CITY OF WARRENTON

Warrenton Planning Commission

From: Skip Urling, Community Development Director

Re: Fisherman's Storage Site Design Review and Conditional Use Applications

PROPOSED GRADING PLAN

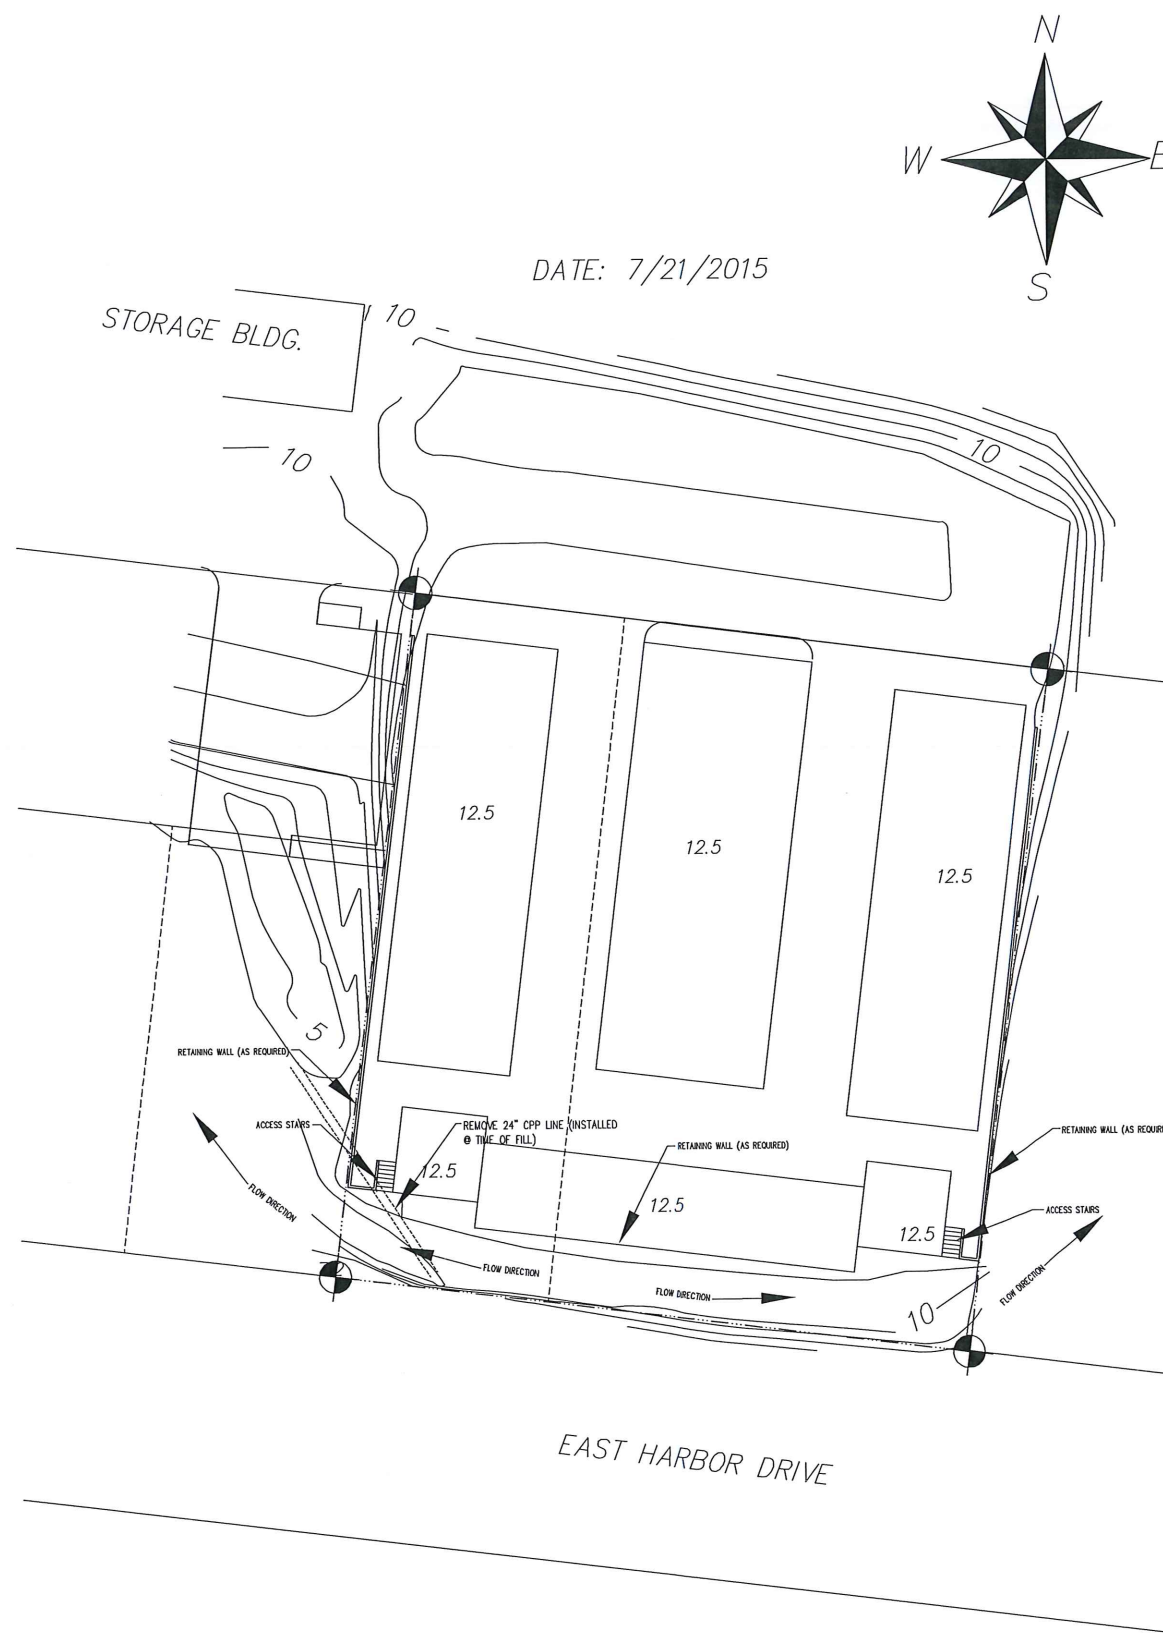
I have reviewed the stormwater information presented on the Fisherman’s Storage plans and calculations. The information presented doesn’t meet the City minimum stormwater requirements or other requirements that have been discussed with the development team. I believe an adequate stormwater report can be prepared to address this proposed development. Because of this, I suggest the project be conditionally approved. Construction shall not begin until after a stormwater plan and report has been submitted to the City. These plans and report shall be approved by the City Engineer prior to any additional work starting on the site. This includes grading, foundation and road work.

The design shall also include the conveyance of stormwater from the existing stormwater ditch that runs along E Harbor Dr. through tax lots 081022BD05100 and 081022BD05200, and any other runoff flowing from west to east between Railroad Ave and E Harbor Dr and affected by the subject property fill, to the existing drainage system located on tax lot 081022BD02600 to the north. In addition, the existing ditch systems located on the development site, including the ditch adjacent to East Harbor Drive, shall be cleaned and maintained to promote drainage of the surrounding area and businesses.

- 3. Construction shall not begin until after a stormwater plan and report has been submitted to the City. These plans and report shall be approved by the City Engineer prior to any additional work starting on the site. This includes grading, foundation and road work. The design shall also include the conveyance of stormwater from the existing stormwater ditch that runs along E Harbor Dr. through tax lots 081022BD05100 and 081022BD05200, and any other runoff flowing from west to east between Railroad Ave and E Harbor Dr and affected by the subject property fill, to the existing drainage system located on tax lot 081022BD02600 to the north. In addition, the existing ditch systems located on the development site, including the ditch adjacent to East Harbor Drive, shall be cleaned and maintained to promote drainage of the surrounding area and businesses.

FIRE ACCESS

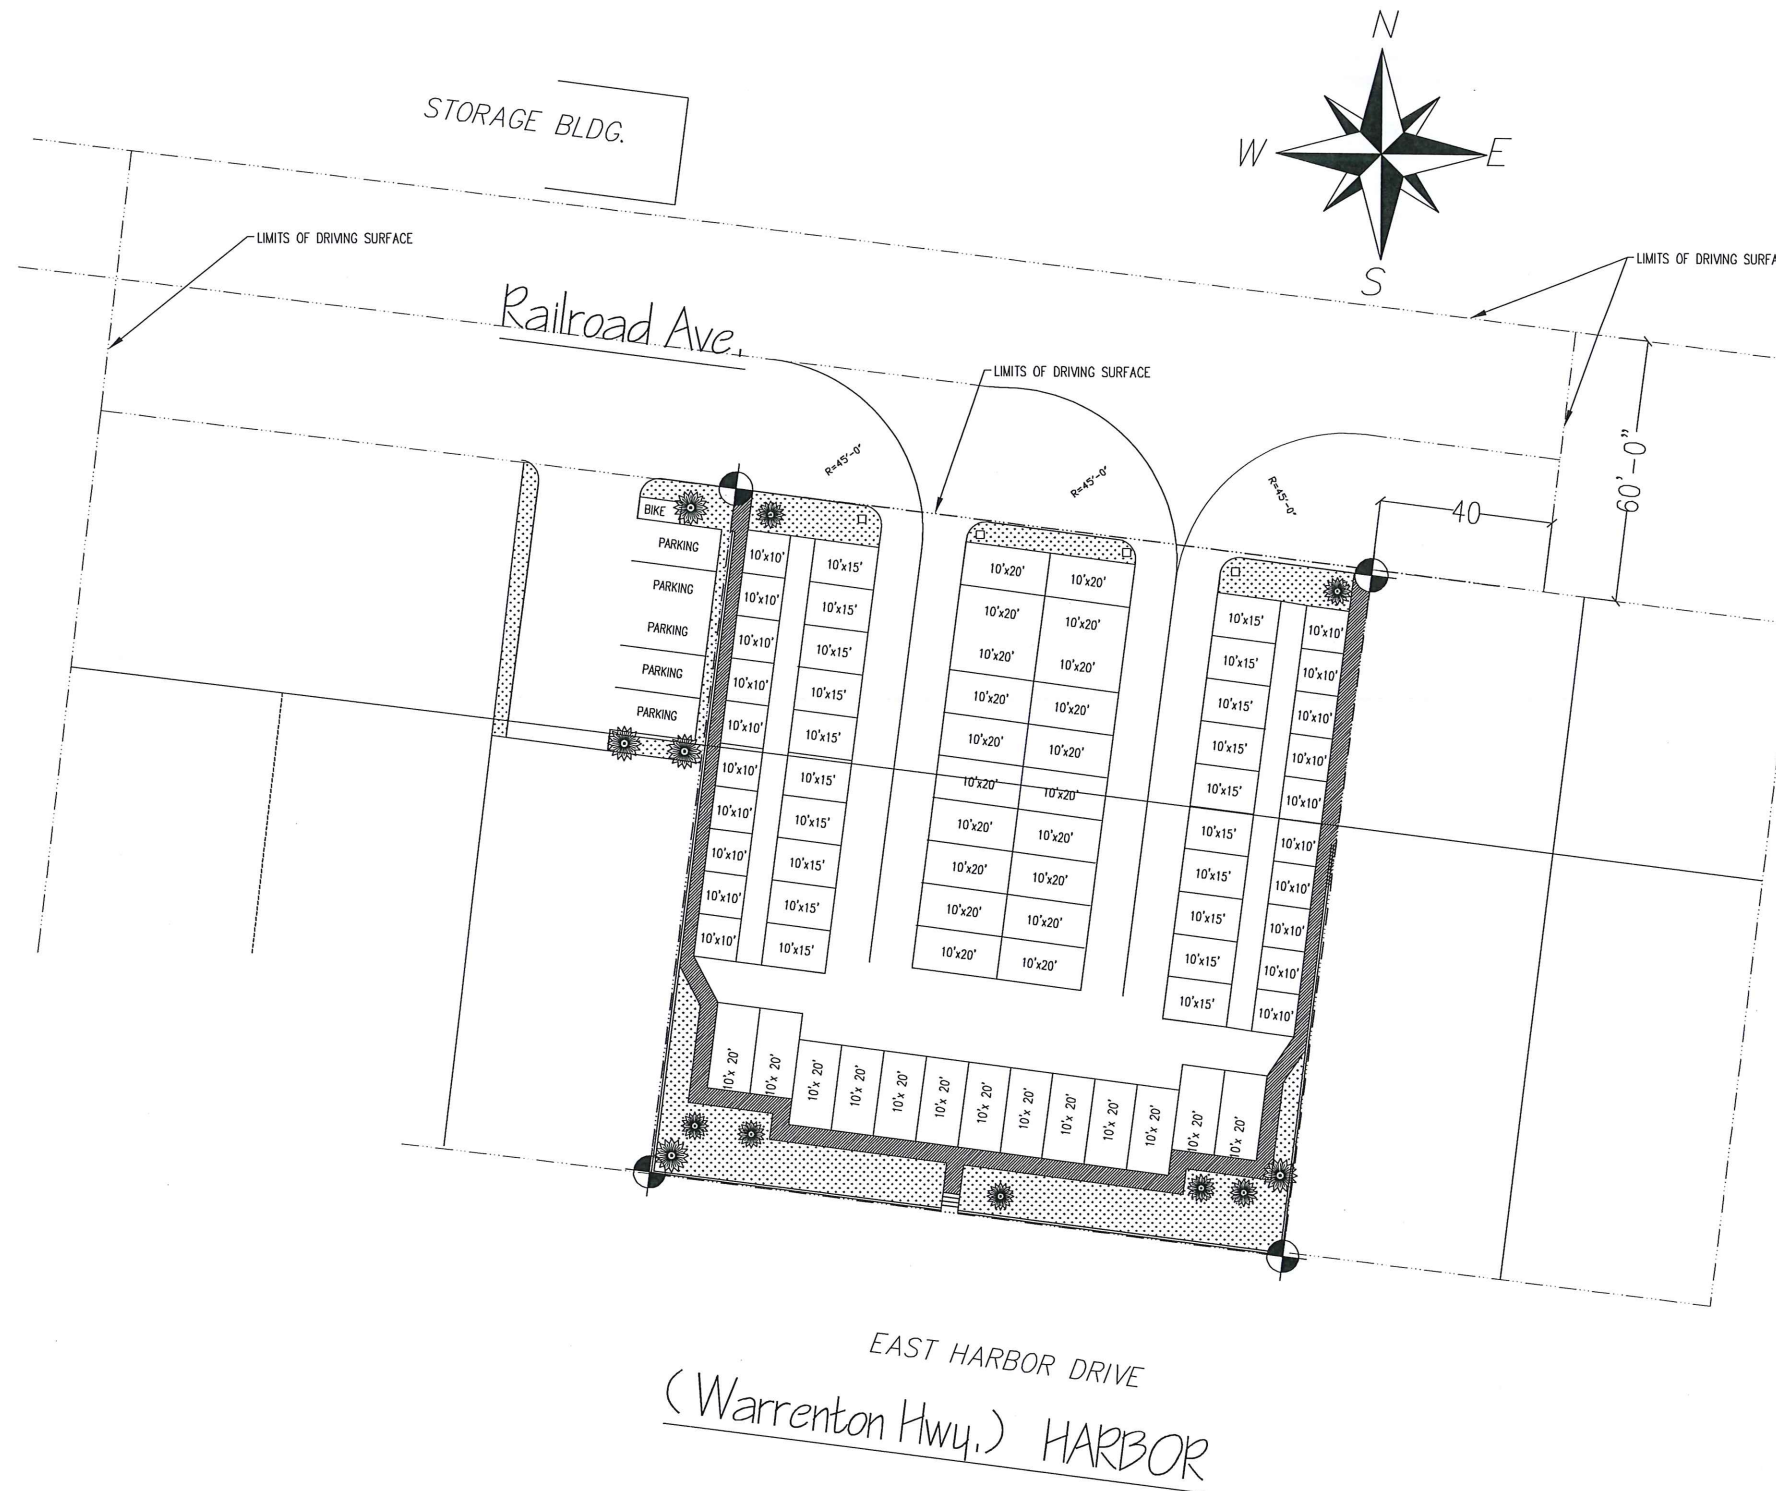
All points around the structure must be accessed within 150 feet. including inside aisles.

Access around the building perimeter in the form of a 4 foot wide walkway/sidewalk has been provided. Surface will need to be preapproved by the Fire Department. This will include the stair access and path to the South section of the structure from East Harbor Drive.

The Fire Department sees the driveway into the structure as a potential bottle neck in the event emergency vehicles need to access the site in an emergency. The aisles between the structures are a minimum of twenty feet wide and appear to be negotiable by fire apparatus. The aisle way will need to be signed no parking, fire lane if used as the turn around.

Corner radiuses of 45 feet or greater have been provided.
